Access Compliance Report Public Rights-of-Way (Curb Ramps)

Main Street: ROSSMOOR_CENTER_WAY		Cross Street: MONTECITO_RD		Location:	SE
ADA ID: RPRK211208114301	Ramp Type: Type 4 - Parallel	Initial Pass/Fail: Fail	Overall Compliance: No	Severity Score:	35

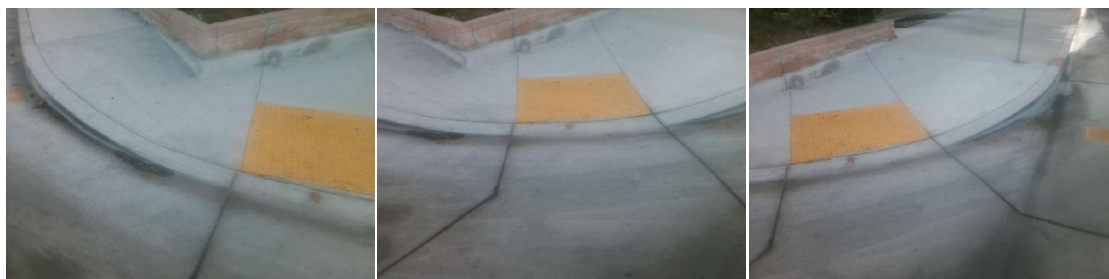
Compliance	Description	Data	Compliance	Description	Data
N/A	Ramp Length LT (in)	93	N/A	Ramp Length RT (in)	77
No	Ramp Width LT (in)	46	Yes	Ramp Width RT (in)	98
Yes	Ramp Run Slope LT (%)	7.2	No	Ramp Run Slope RT (%)	12.5
Yes	Ramp Cross Slope LT (%)	0.4	No	Ramp Cross Slope RT (%)	4.1
N/A	Landing Present	N/A	N/A	DWS Provided	N/A
N/A	Landing Length (in)	N/A	N/A	DWS Contrast	N/A
N/A	Landing Width (in)	N/A	N/A	DWS Length (in)	N/A
N/A	Landing Run Slope (%)	N/A	N/A	DWS Full Width	N/A
N/A	Landing Cross Slope (%)	N/A		DWS Offset Type	N/A
N/A	Landing Movement Obstructed?	N/A	N/A	DWS Offset Left (in)	N/A
	Landing Movement Type	N/A	N/A	DWS Offset Right (in)	N/A
N/A	Landing Shared	N/A			
N/A	Clear Space	Yes			
N/A	Clear Space To Crosswalk (in)	48			
N/A	Marked Crosswalk 1	Yes	N/A	Marked Crosswalk 2	Yes
	Crossing 1 Direction	N		Crossing 2 Direction	W
	Marked Crosswalk 1 Width (in)	144		Marked Crosswalk 2 Width (in)	144

Remove & Replace Curb Ramp With Two New Directional Ramps or Equivalent.

R304.5.1, R304.3.2, R304.5.3, STD 1115
